Datasheet Change Notice

HE Series Helical Antennas

Figure 1: Number of coils more accurately represented

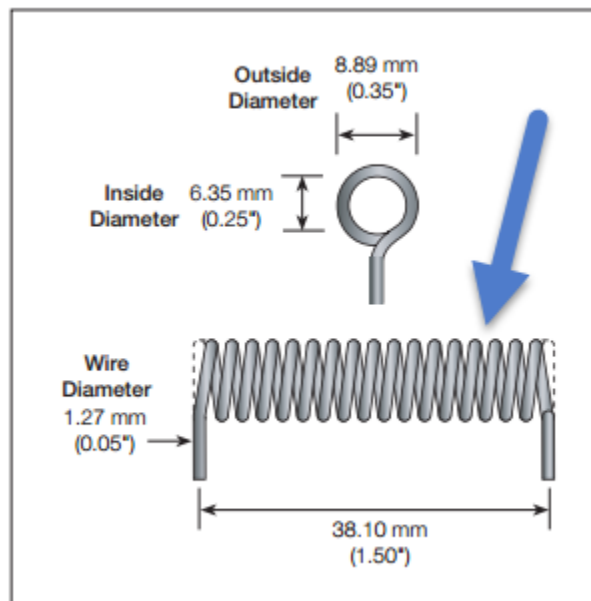
Please note that we have made an update to our [HE Series Antennas](#), where we have made small corrections to the drawings. Please update your systems to show these new datasheets and discard the older versions.

Part Number	Change
ANT-315-HESM	Now shows 17 coils
ANT-315-HETH	Now shows 17 coils
ANT-418-HESM	Now shows 12 coils
ANT-418-HETH	Now shows 12 coils
ANT-433-HESM	Now shows 11 coils
ANT-433-HETH	Now shows 11 coils
